# TECHNICAL INFORMATION

**Product Category:** Plasma TV / Plasma IDTV

**Subject:** PSS Board operation stability problem

**Model(s) Affected:** TX-P42/50X50B TX-P42/50XT50E TX-PR42/50XT50  
TX-P42/50X50E TX-P42/50XT50Y  
TX-P42/50XT50B TX-PR42/50X50

Fig. 1: General location

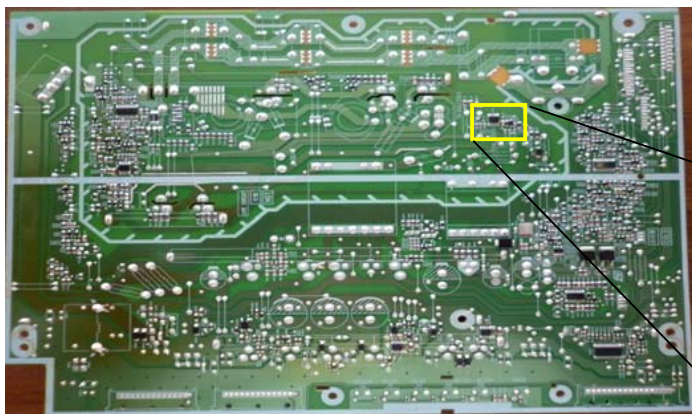
**Symptom / Cause:** Following a certain sequence of events, the television does not power on and there is no standby LED lit. For example after disconnecting from the mains supply, then re-connecting within 3 minutes.

Replace IC U203 on the foil side of the PSS-PCB. (See Fig. 1 and Fig. 2 for U203 location details.)  
Order kit part number: TZS9EK097

After replacement of the power management IC the TV may not start up on the first attempt. This is due to the protection circuit contained on the main board. To remove the protection error code from the main board, switch off the TV by isolating it from the mains and wait for a few minutes. You may have to repeat this process a few times before the error code(s) are removed.
